RAI 5:

Response to Request for Comment on Draft Safety Evaluation for AREVA Inc. Topical Report EMF-2328(P)(A), Revision 0, Supplement 1, Revision 0, "PWR Small Break LOCA Evaluation Model, S-RELAP5 Based" (TAC No. ME8227)

EMF-2328(NP)(A)
Revision 0
Supplement 1
Revision 0

PWR Small Break LOCA Evaluation Model,
S-RELAP5 Based

Figure 5-1: Break Mass Flow Rate – W 3-Loop

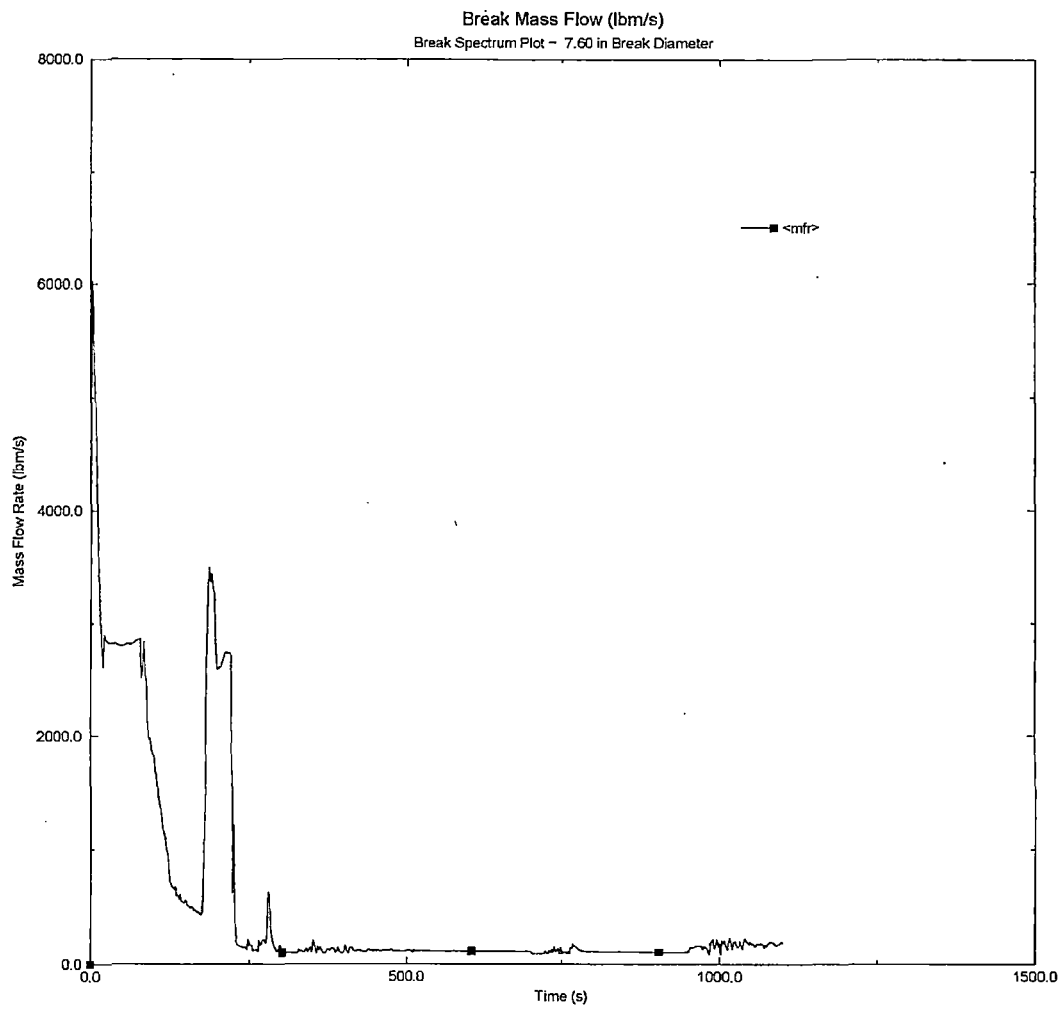
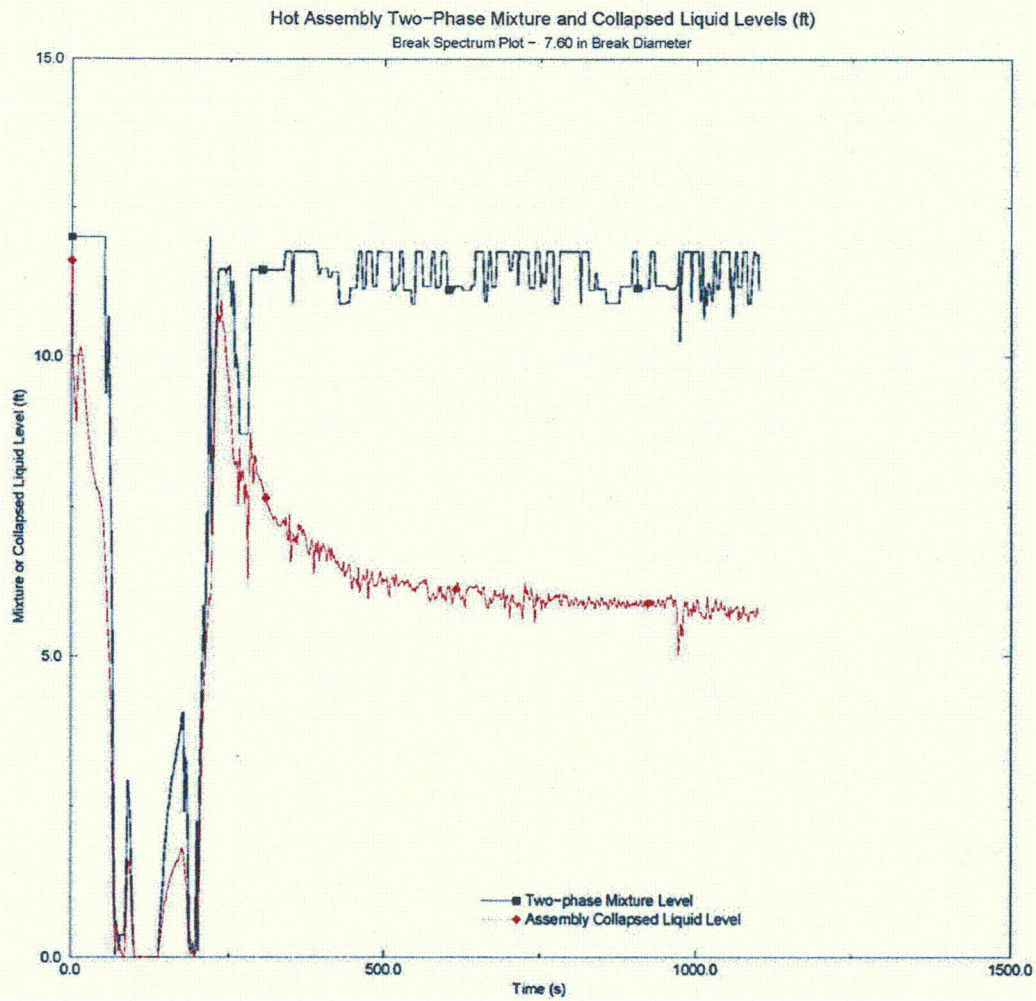
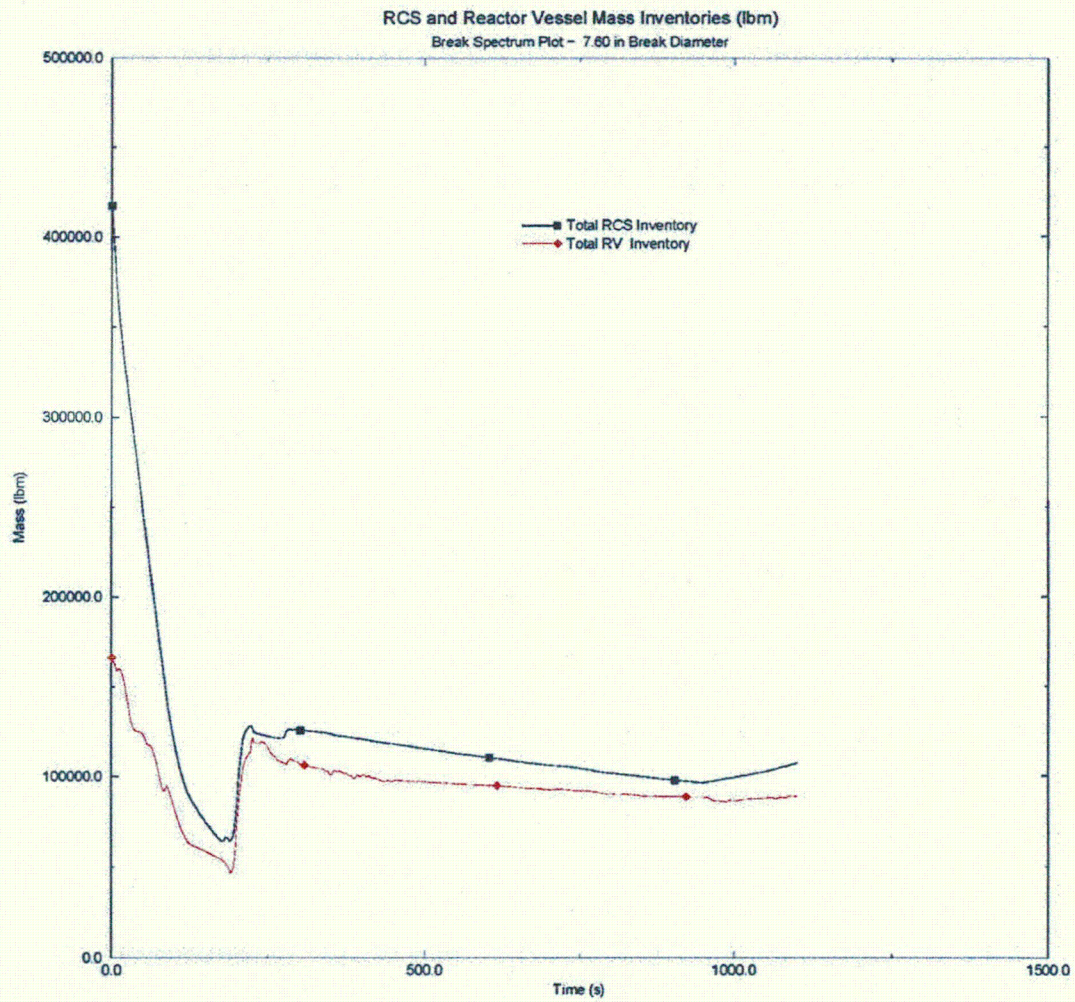
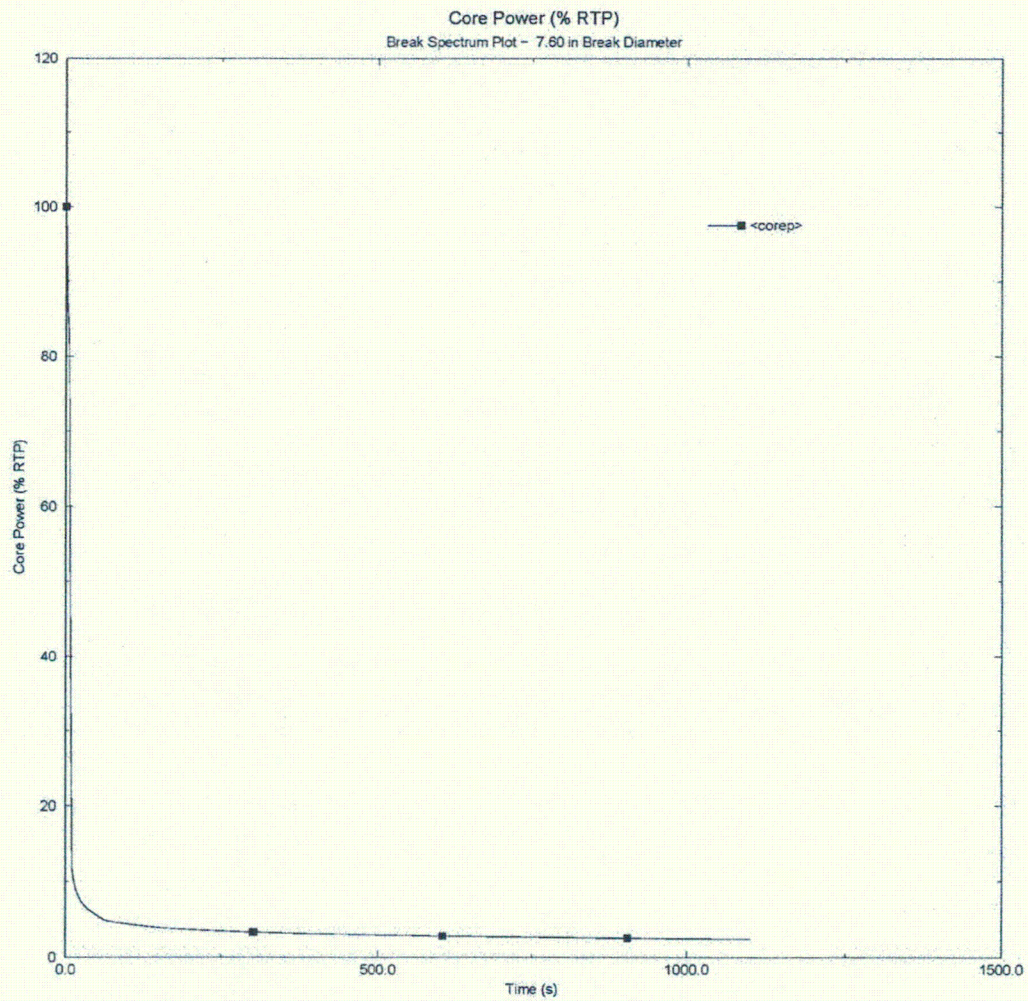
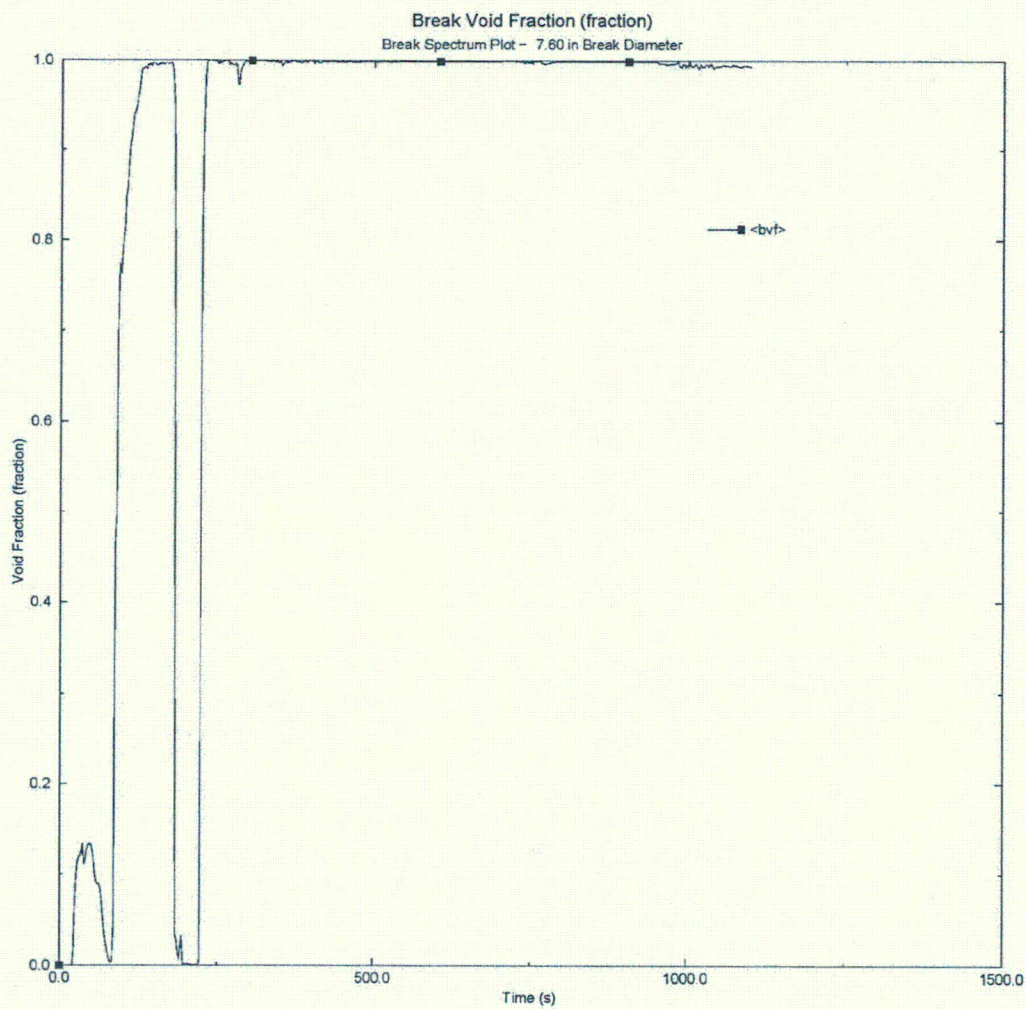
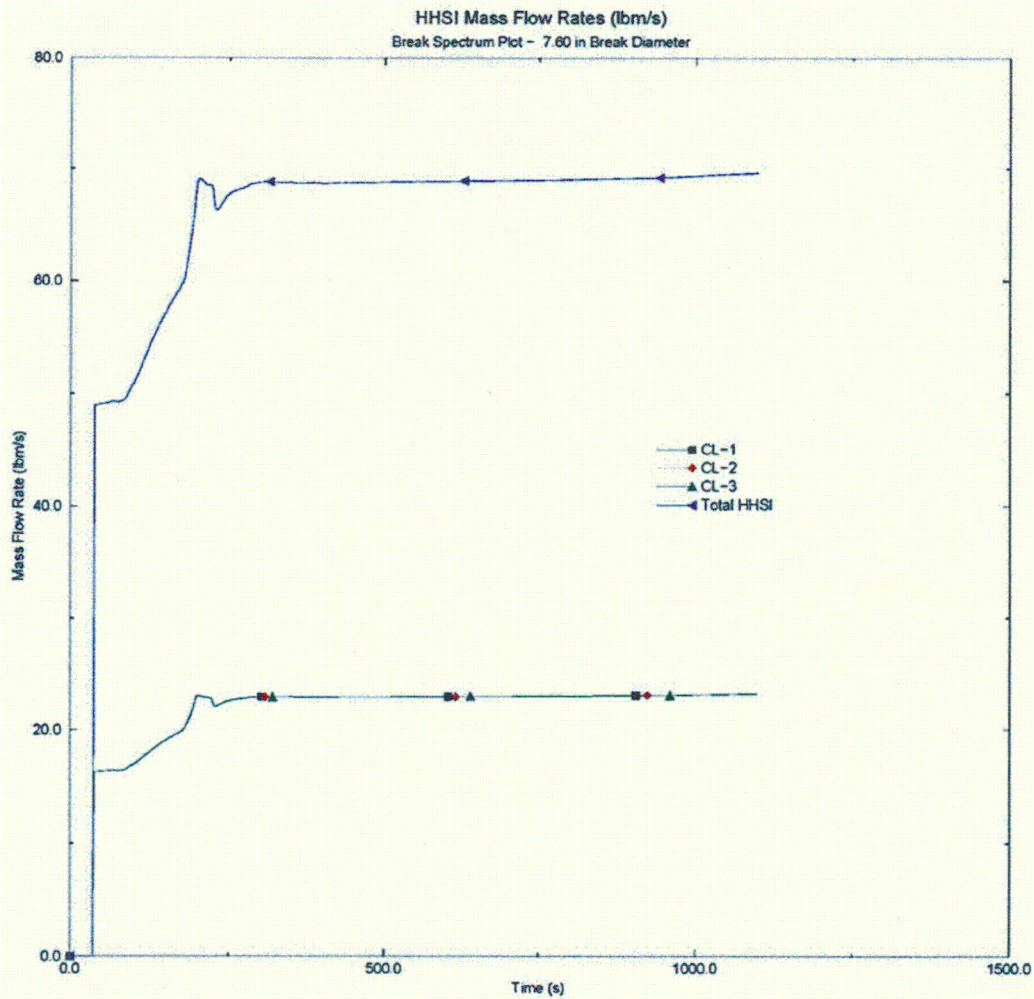
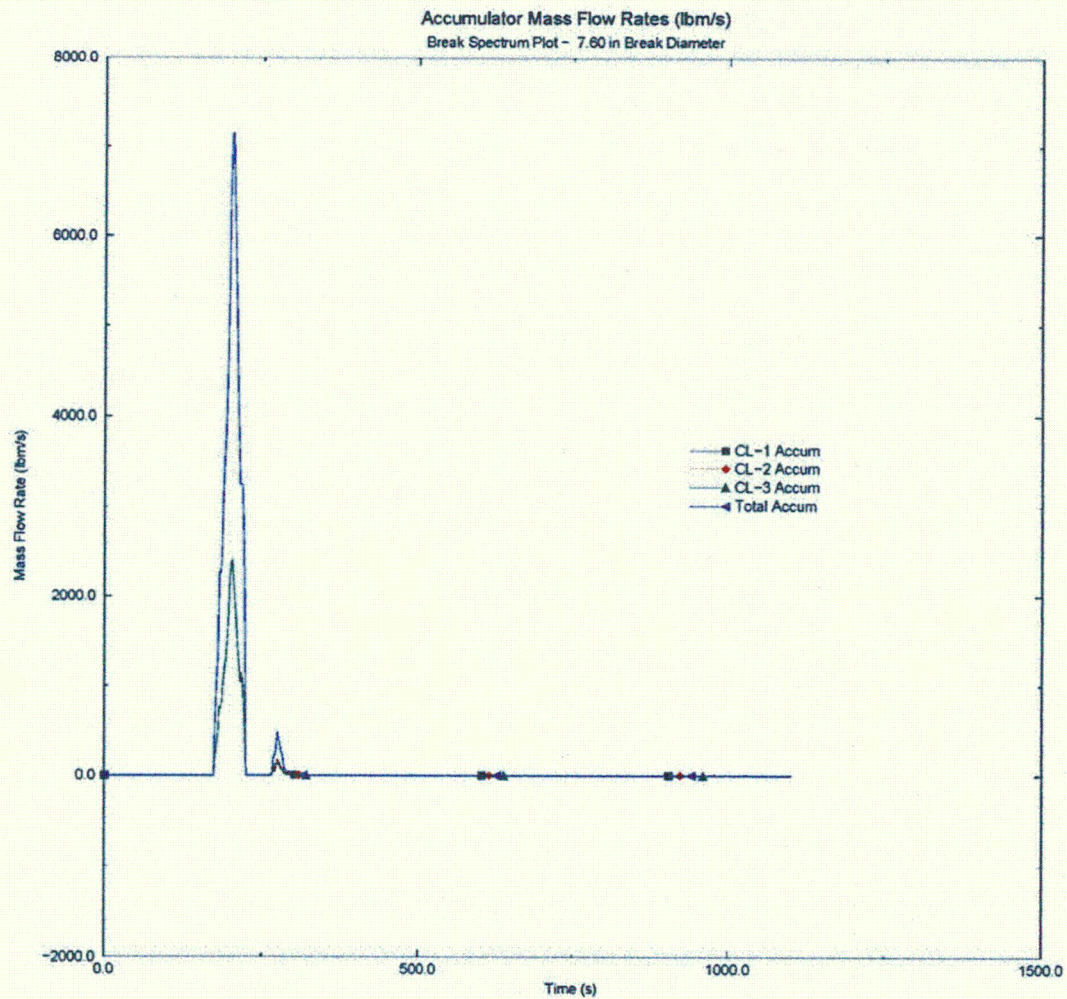
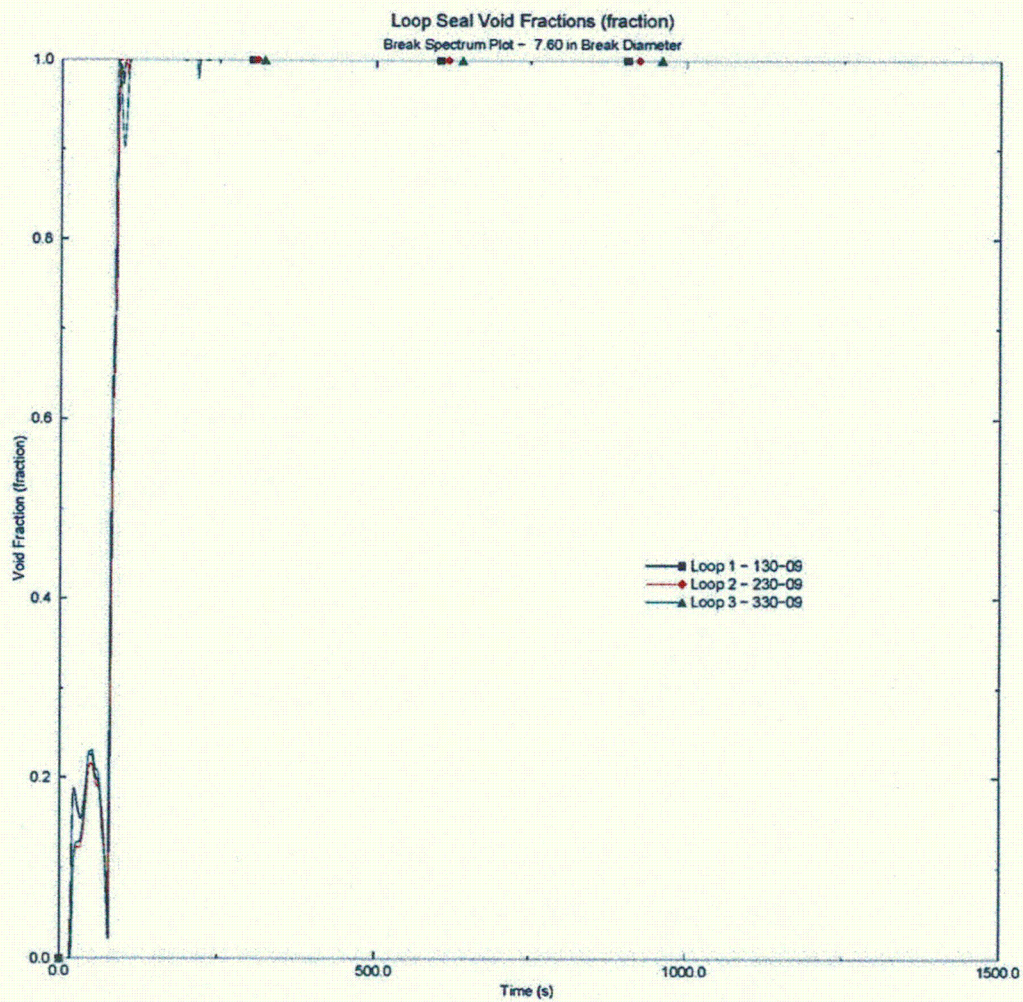
Please provide a plant sample break spectrum analysis with all of the EMF-2328(P)(A), Revision 0, Supplement 1, Revision 0, changes included. This could be accomplished by comparing the results of a sample plant SBLCOA spectrum with and without the EMF-2328(P)(A), Revision 0, Supplement 1, Revision 0, changes. This should include the severance of the safety injection line, as well.

The limiting break for a cold leg pump discharge (CLPD) break, an accumulator line break, and a pumped SI line break are presented in Table 5-2, Table 5-3, and Table 5-4, respectively. The results from the break spectrum analysis are presented in Table 5-5. The limiting PCT is 1735°F for a 7.6 inch equivalent pipe diameter break size. A listing of the sequence of events for each break size in the spectrum is shown in Table 5-6a through Table 5-6c. Plots of some of the more important parameters for the limiting break of 7.6 inches are presented in Figure 5-1 through Figure 5-16.

A double ended break in the accumulator piping or in the pumped SI piping connecting to the RCS does not produce a limiting case. An acceptable amount of emergency core cooling flow is delivered to the intact loops in both cases.
